**From:** [REDACTED]  
**To:** [Per BlackpoolSchemeConsultation](#)  
**Subject:** River Bride (Blackpool) Drainage Scheme Public  
**Date:** Thursday 23 January 2020 12:39:39  
**Attachments:** [image001.png](#)

**Re: River Bride (Blackpool) Certified Drainage Scheme - Arterial Drainage Acts 1945 and 1995.**

Re: EIA Consultation relating to proposed River Bride (Blackpool) Drainage Scheme

Drg. No. RB\_204 Proposed Flood Defences - Plan Layout (Sheet 4 of 12)

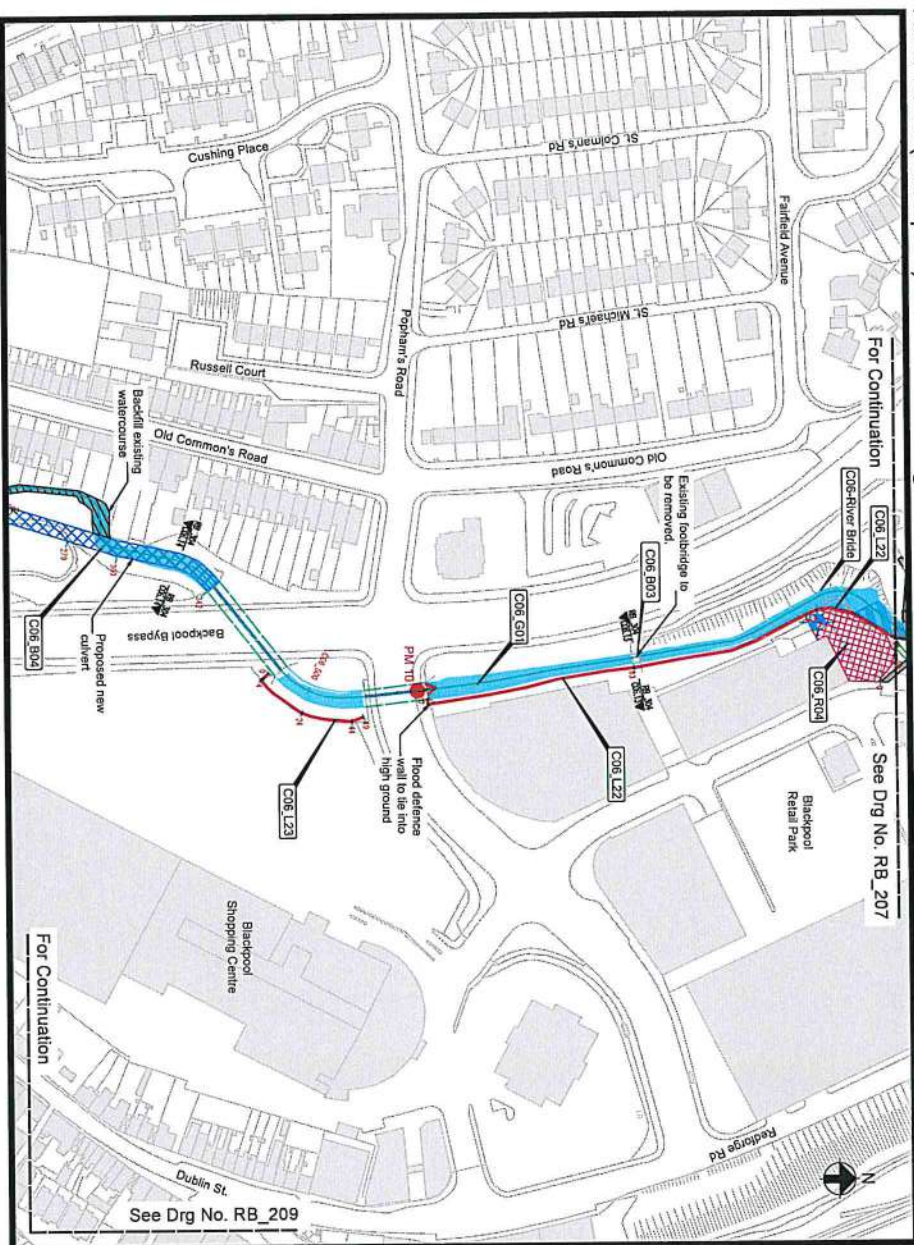
- Works are proposed adjacent to CC-N20-001.00 Kilnap Bridge, see Drg. RB\_204. The proposals appear to include for diverting floodwater along the toe of the bridge embankment and onto the road, although further details including cross-sections are necessary to develop a full understanding of the proposals. TII have concerns regarding the potential for scour at the toe of the embankment and would not be in favour of accepting the proposal; at the very least TII need to see further detailed consideration of the effects of the proposals on the embankment, and proposed mitigation measures to protect the embankment. Is it acceptable to the road authority that the road surface under the bridge is to be used as a conduit for excess floodwaters? It appears there is an option to replace the apparently undersized pipe which is causing the flooding, although the replacement is likely to be a more expensive option than the current proposal.

Dwg. No. RB\_208 Proposed Flood Defences - Plan Layout (Sheet 8 of 12)

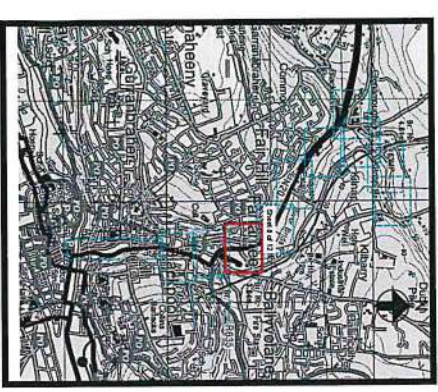
- Works are proposed adjacent to CB-N20-004.00 Blackpool Shopping Centre Culvert, see Drg. RB\_208. The existing culvert is a precast RC segmental arch structure. The proposals include the construction of Flood Defence Walls adjacent to and abutting the north east end of the culvert. TII have concerns regarding the potential increase in river flows at Blackpool shopping centre culvert and the raised potential for scour at the structure if the proposals proceed to construction. I need to see a scour inspection and assessment report, which shall be completed by the applicant in accordance with the UK DMRB BD 97/12 and the attached scour assessment requirements. The report will confirm the likelihood of scour damage arising, and the mitigation measures necessary to prevent scour if the proposals proceed to construction. At the south west end of the structure the proposals include for replacing the existing open channel with a reinforced concrete culvert which appears to abut CB-N20-004.00. The proposed culvert is of shorter span than the existing culvert. TII have concerns regarding the potential for scour at the interface between the two structures and would ask the applicant to provide details of hydraulic modelling to confirm the likelihood of scour developing at the interface between the structures, and the mitigation proposed if the hydraulic model confirms the potential for scour. TII also need to see details of the proposal to abut the new culvert against the existing arch structure.
